8.5. Crows Nest Over Station Development Amended Concept Plan

To report to Council the Crows Nest Over Station Development Concept Plan as has been amended since it was last exhibited in late 2018 and recommend that Council make a submission in response.

Source: Crows Nest - Over Station Development Appendix A - Architectural Drawings of Proposed OSD Building Envelope - DPIE 2020

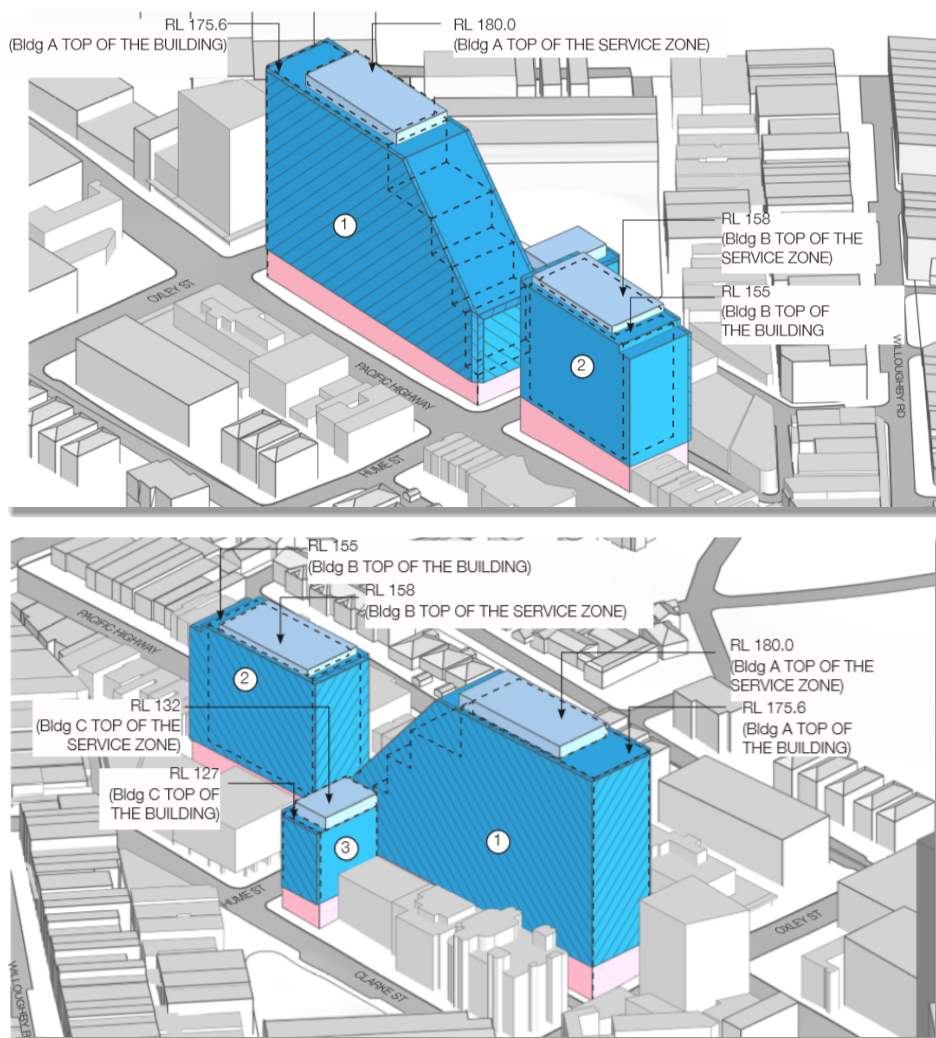
Council previously submitted that the bulk and massing of the building form is of particular concern given the tall slender tower forms currently under consideration and construction. DPIE has argued that the concept is only an envelope at this stage and that it has been further reduced since its initial lodgment by a small reduction in height and chamfering of the southern corner of Building A.

The amendments are noted. As discussed briefly in 2.6 above, the bulk and massing shown on the exhibited documents, have the capacity to be somewhat incongruent with both the emerging character of St Leonards and the existing character of Crows Nest.

2.6 View and Visual Impacts

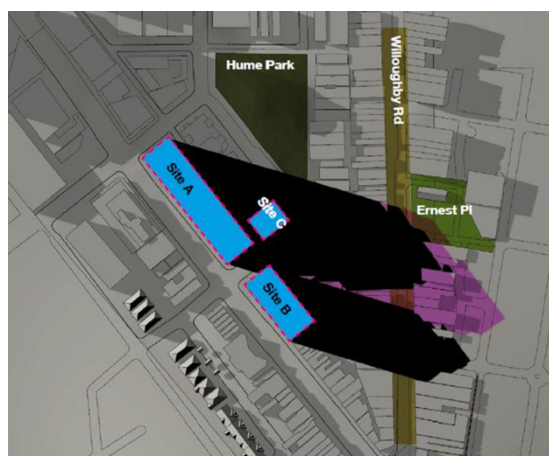
Council previously submitted that the representation of the visual impacts were somewhat misleading and that it was important to accurately reflect the significant impacts that would arise. DPIE agreed with the lack of accuracy. The visual impact studies have now been updated.

As has been well documented, the character of Crows Nest comprises low density, low scale development with a high degree of fine grain detailing and amenity. Whilst the architectural quality of a future development application will be relevant, the amended building envelope has a high propensity to be quite overbearing and potentially inconsistent with the highly valued character of Crows Nest. Further submissions will be made on this point.
